AEP:NRC:3054-06
10 CFR 2.202

Donald C. Cook Nuclear Plant Unit 1 and Unit 2
RESPONSE TO REQUEST FOR ADDITIONAL INFORMATION
REGARDING RELAXATION OF REACTOR PRESSURE VESSEL HEAD
PENETRATION INSPECTION REQUIREMENTS IN NUCLEAR
REGULATORY COMMISSION ORDER

RESPONSE TO REQUEST FOR ADDITIONAL INFORMATION

Sketch of D.C. Cook Unit 1 and Unit 2 Reactor Vessel Head Penetration
(Not to Scale)

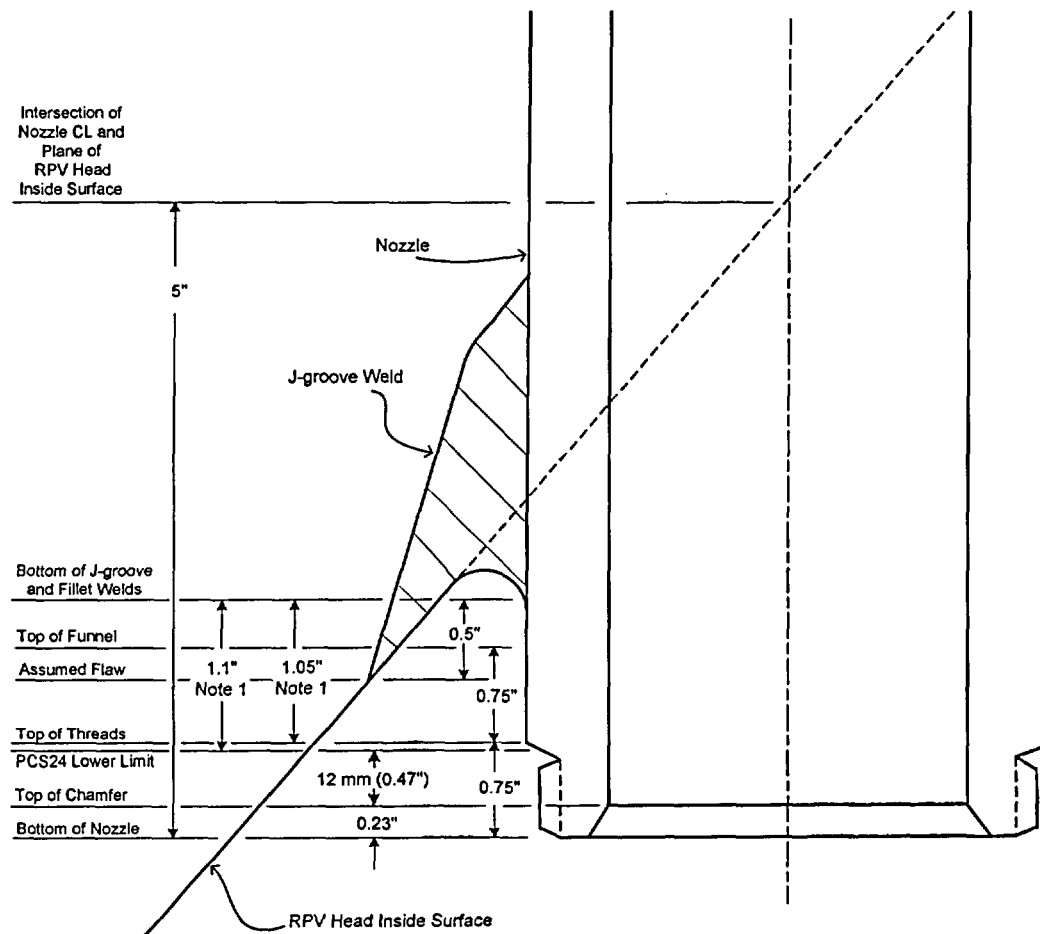
The licensee stated that a small portion of base material will not be scanned on the bottom of the nozzle because the lower transducer and the upper transducer of the probe need to be in contact with the nozzle material. The distance from the bottom of the nozzle upward that cannot be scanned is 12 mm. Please identify the minimum distance from the J-groove weld to the location on the nozzle that cannot be scanned.

The licensee is requested to provide a sketch of the nozzle with the necessary dimensioning to clarify the areas covered by the request.

Provide the distance from the bottom of the weld to the point where ET/PT cannot be performed.

As shown in the sketch provided at the end of this attachment, the distance from the bottom of the nozzle upward that cannot be scanned due to the PCS24 probe transducer arrangement has been calculated to be 12 millimeters (0.47 inches) plus the height of the chamfer (0.23 inches). The minimum distance downward from the J-groove weld to the location on the nozzle that cannot be ultrasonically scanned due to the PCS24 probe transducer arrangement has been calculated to be 1.1 inches. Due to the curvature of the RPV head, this minimum distance only occurs at one point on the downhill side of the outermost penetrations (six penetrations on Unit 1 and five penetrations on Unit 2).

A sketch has been provided at the end of this attachment.

The nozzles that have guide funnels installed are the outermost nozzles. As shown in the sketch provided with this attachment, the guide funnels extend approximately 0.75 inches above the threads. Consequently, the minimum distance from the J-groove weld to the location on the nozzle that cannot be examined by eddy current testing or dye penetrant testing on nozzles that have funnels installed is less than the distance assumed in the crack growth calculation described

GRAPHS OF STRESS VERSUS DISTANCE BELOW J-GROOVE WELD

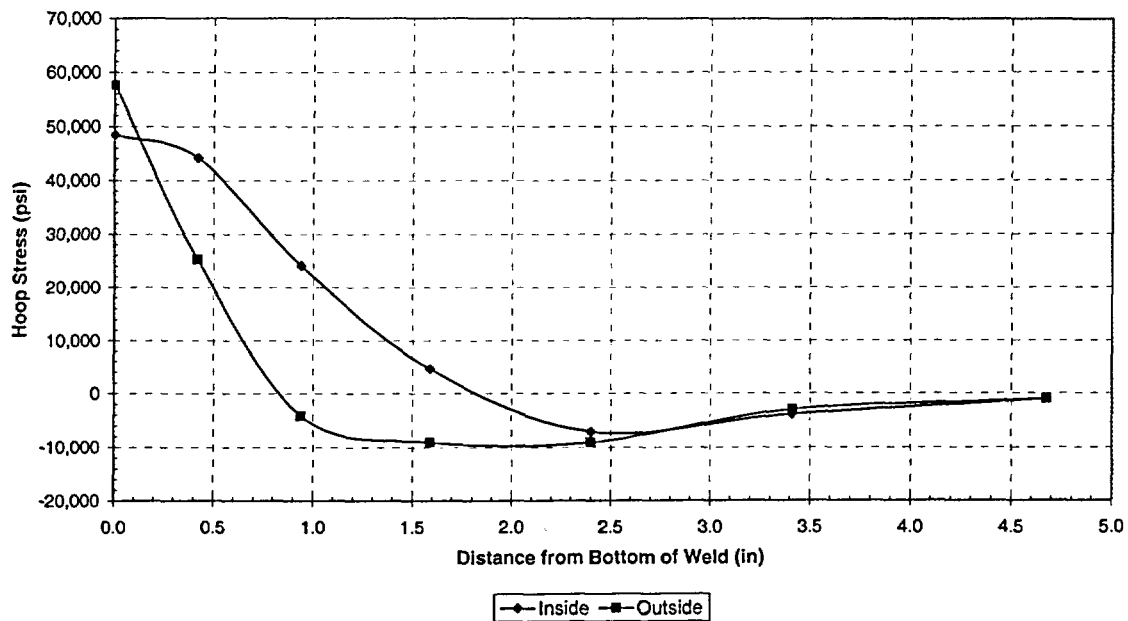
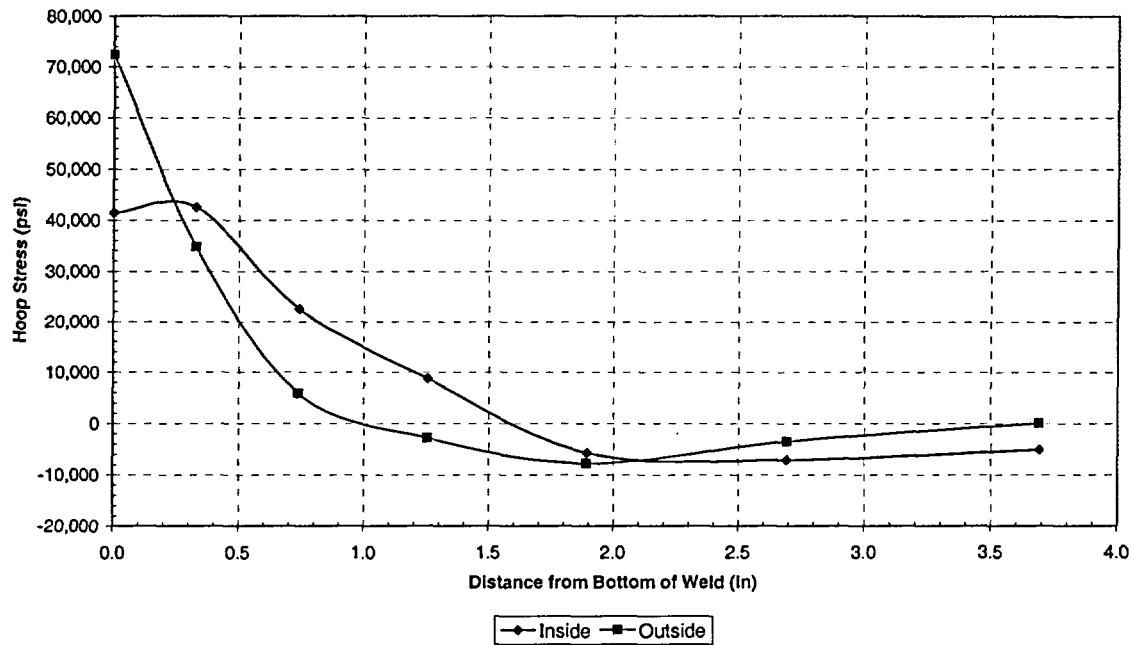
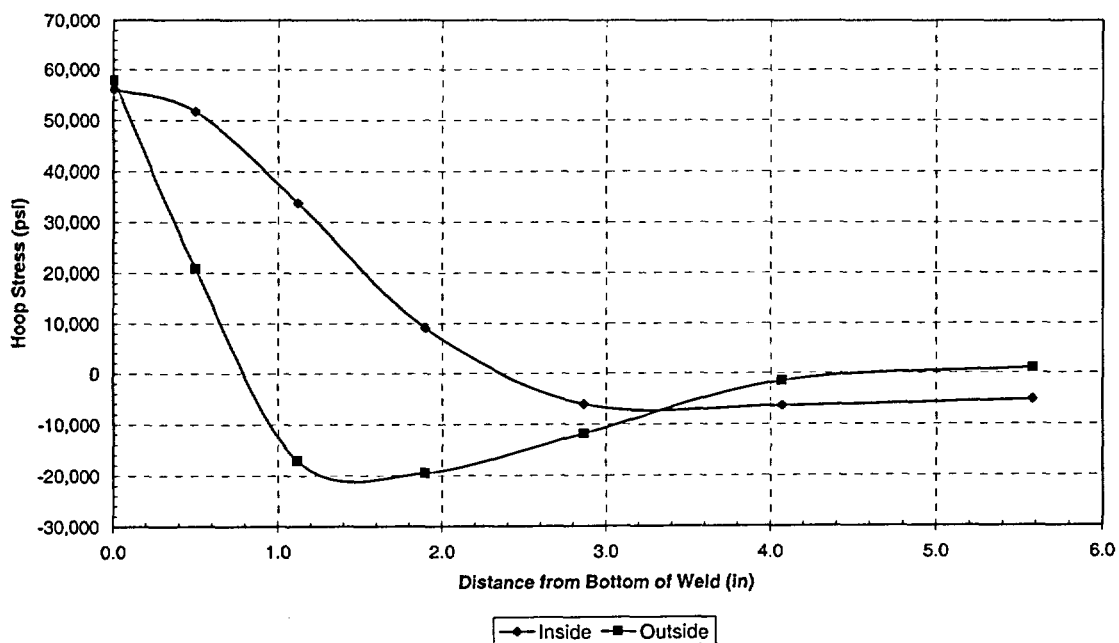
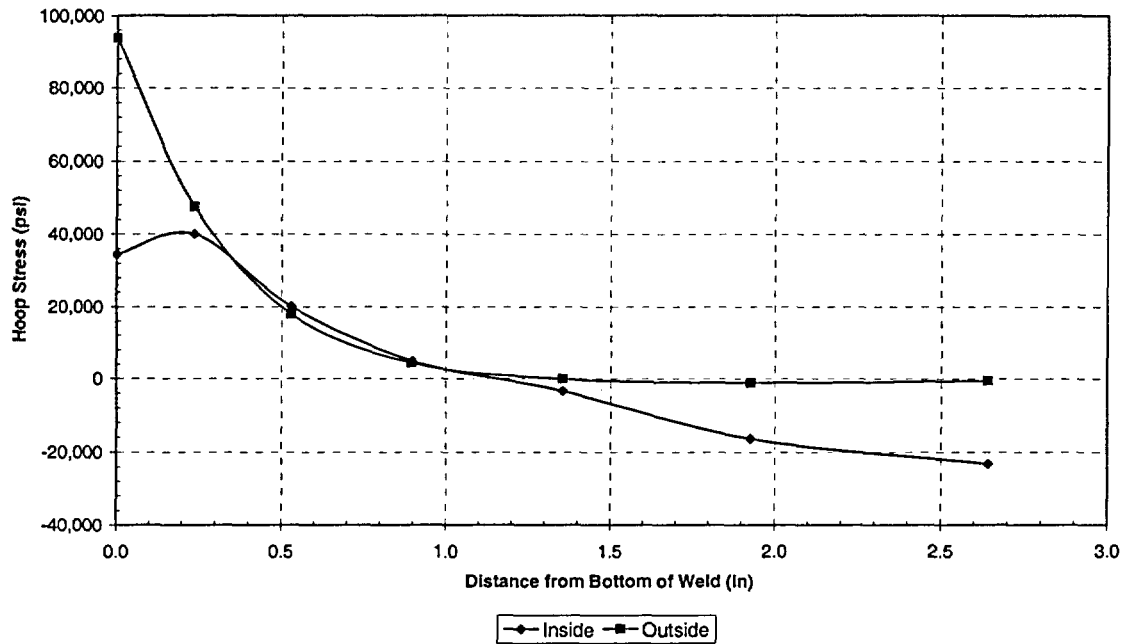
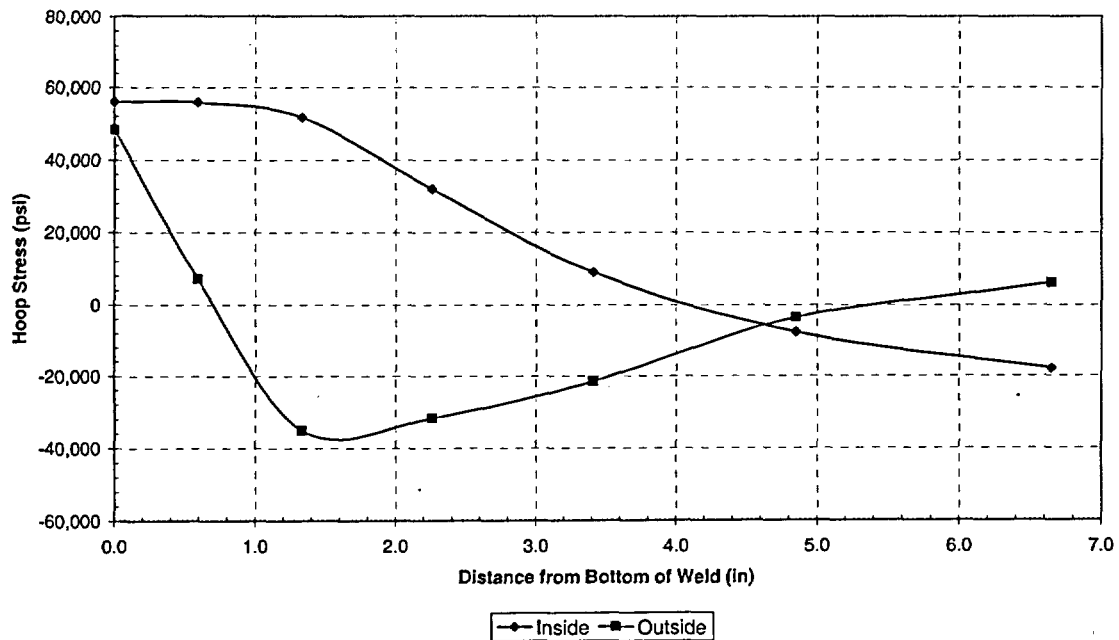
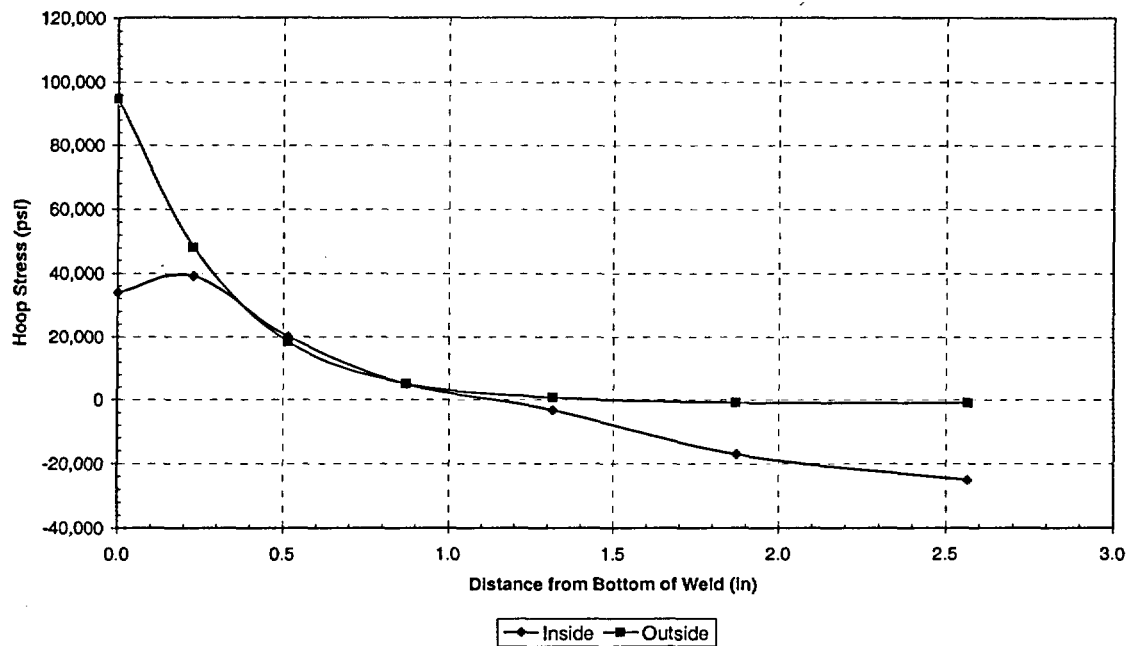
Provide additional technical justification (i.e., operating stress levels, crack growth analysis, etc.) that supports the licensee's statement that the small area that cannot be scanned is insignificant to the phenomena of concern.

The operating stresses in that area are shown in Attachment 2 to this letter, which provides graphs of hoop stress versus distance below the J-groove weld for various nozzles from the center of the Unit 2 RPV head to the outermost row. As shown in these graphs, the stresses in the area of the nozzle that would not be inspected are low relative to the yield stress of the nozzle material (41,000 to 63,000 pounds per square inch).

**Hoop Stress Distribution Below the Weld Downhill Side
(50.5° CRDM Penetration Nozzle)**

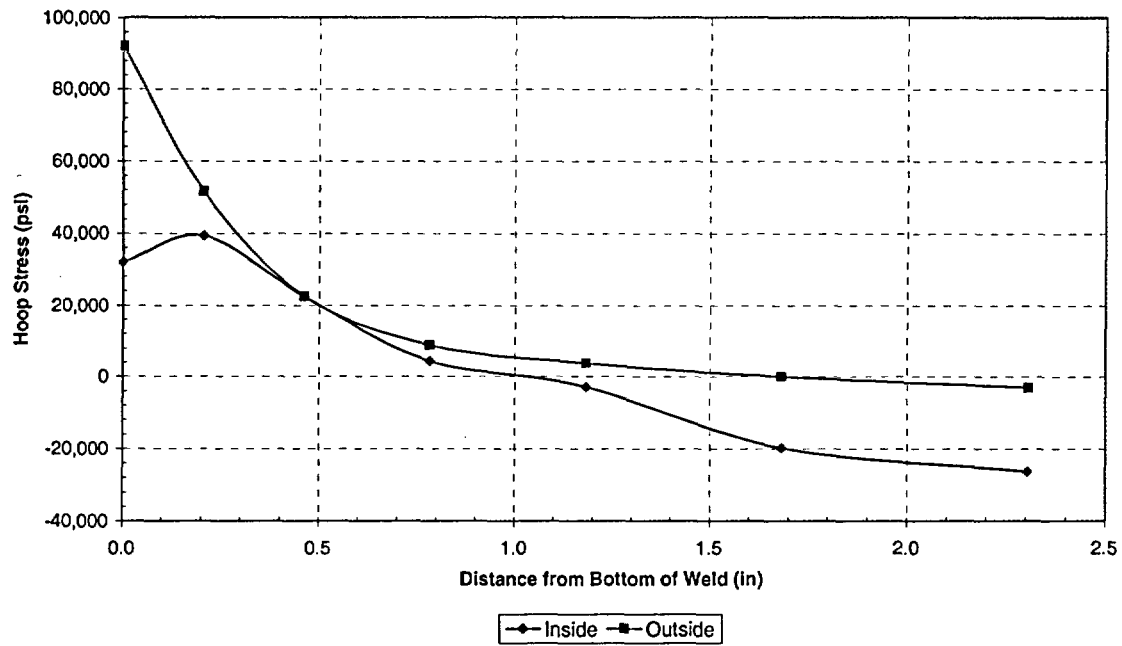
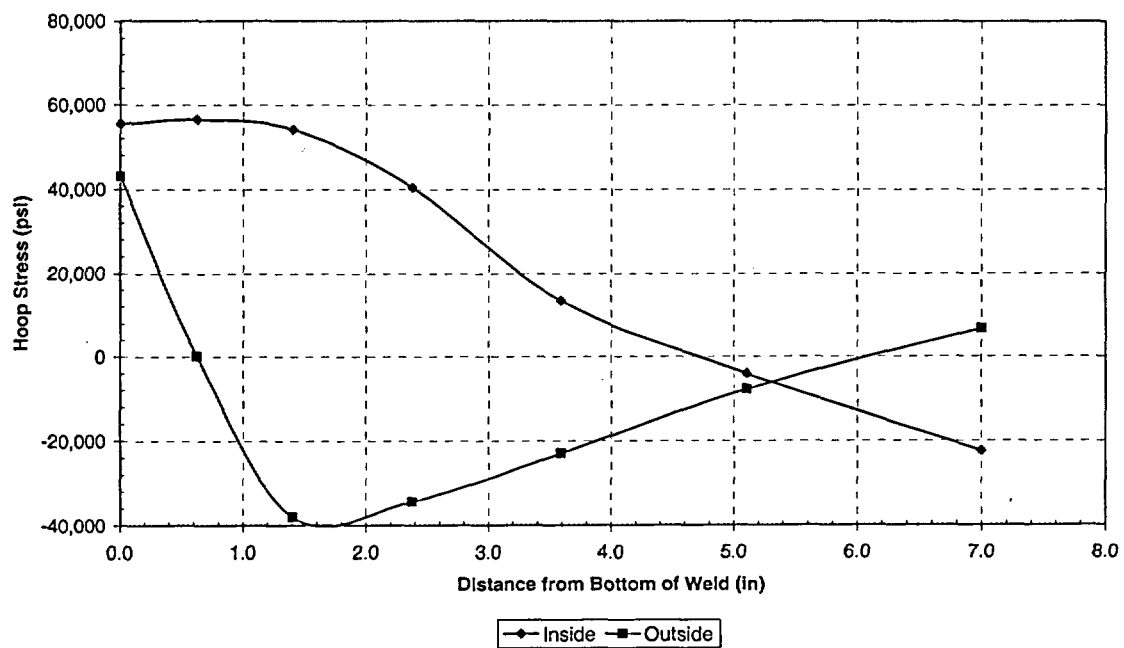
The licensee stated that at least five nozzles are threaded approximately 0.75 inches at the bottom of the nozzle. Provide the distance from the bottom of the weld to the threaded area that cannot be examined by UT. Additionally, please provide a more exact count of the nozzles that would be affected.

The minimum distance from the J-groove weld to the threaded area has been calculated to be 1.05 inches. Due to the curvature of the RPV head, this minimum distance only occurs at one point on the downhill side of the outermost penetrations (labeled 50.5° in Attachment 2, six penetrations on Unit 1, five penetrations on Unit 2). The minimum distance from the J-groove weld to the threaded area for all other points on these penetrations, and for all points on the other 73 penetrations, exceeds this value. As indicated in the response to NRC Question 1 above, the minimum distance from the J-groove weld to the location on the nozzle that cannot be ultrasonically scanned due to the PCS24 probe transducer arrangement has been calculated to be 1.1 inches. Since this value is approximately equal to the 1.05 inch minimum distance to the threaded area, the minimum distance from the J-groove weld to the location on the nozzle that cannot be ultrasonically inspected due to both causes will be considered to be approximately 1 inch.
